RECALL 22V477, 2022-358 REMEDY INSTRUCTIONS

Make(s): CATALINA & AURORA
Model(s): SEE BELOW
Model Year(s): 2020, 2021 & 2022

Concern:
THE BATTERY/HOUSE AND THE
BREAKAWAY WIRING IS INCORRECT ON
THE BATTERY DISCONNECT.

FIGURE 2 (VIEW FROM TOP)

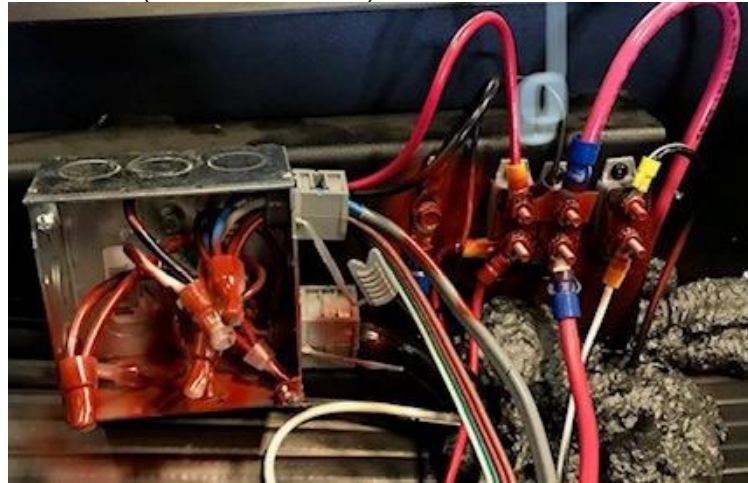
STEP 2: CUT AN ACCESS HOLE ROUGHLY 12" X 12" DIRECTLY BEHIND THE FRONT CROSS MEMBER AND BATTERY DISCONNECT. SET 12" X 12" UNDERBELLY ASIDE FOR LATER USE. THIS WILL GIVE YOU ACCESS TO THE JUNCTION BOX AND AUTO-RESET MINI BREAKERS (FIG. 2);
